UNITED STATES PATENT AND TRADEMARK OFFICE

APPLICATION NO.	FILING DATE	FIRST NAMED INVENTOR	ATTORNEY DOCKET NO.	CONFIRMATION NO.
10/612,166	07/03/2003	Sei-Chang Chang	BHT-3111-337	4160

Office Action Summary

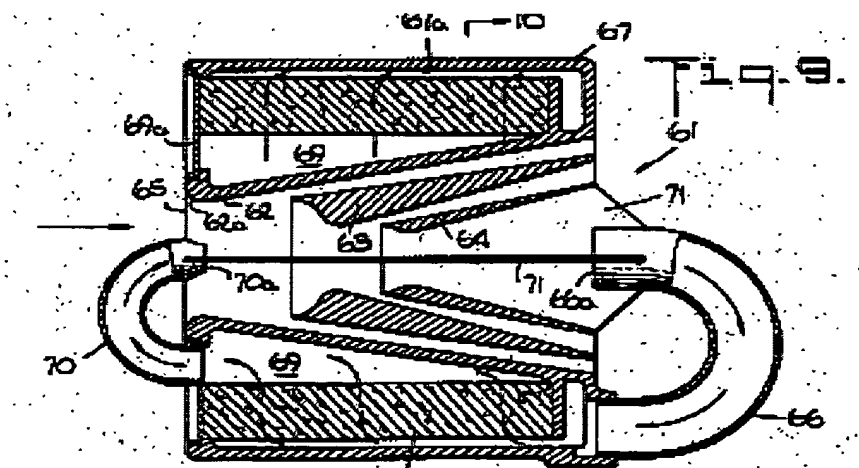
The drawings are objected to under 37 CFR 1.83(a). The drawings must show every feature of the invention specified in the claims. Therefore, the “spiral diversion device” of claims 2 and 9; the “spiral fins on an outer rim of the diffuser” as recited in claims 4 and 10; “the drain outlet” as recited in claims 5-6 and 11, must be shown or the feature(s) canceled from the claim(s). No new matter should be entered.

The drawings are objected to under 37 CFR 1.83(b) because they are incomplete. 37 CFR 1.83(b) reads as follows:

The drawings are objected to as failing to comply with 37 CFR 1.84(p)(5) because they do not include the following reference sign(s) for the “nozzle,” the unlabeled port in the upper right of Fig. 3, “supporters 43,” the “tapered section,” the “throat section,” and the “flared section.” A proposed drawing correction or corrected drawings are required in reply to the Office action to

Claims 1-11 are rejected under 35 U.S.C. 112, first paragraph, as failing to comply with the enablement requirement. The claim(s) contains subject matter which was not described in the specification in such a way as to enable one skilled in the art to which it pertains, or with which it is most nearly connected, to make and/or use the invention. It is unclear how "cross-flow/5" passes through the apparently solid walls of the diffuser, as illustrated in Fig. 3.
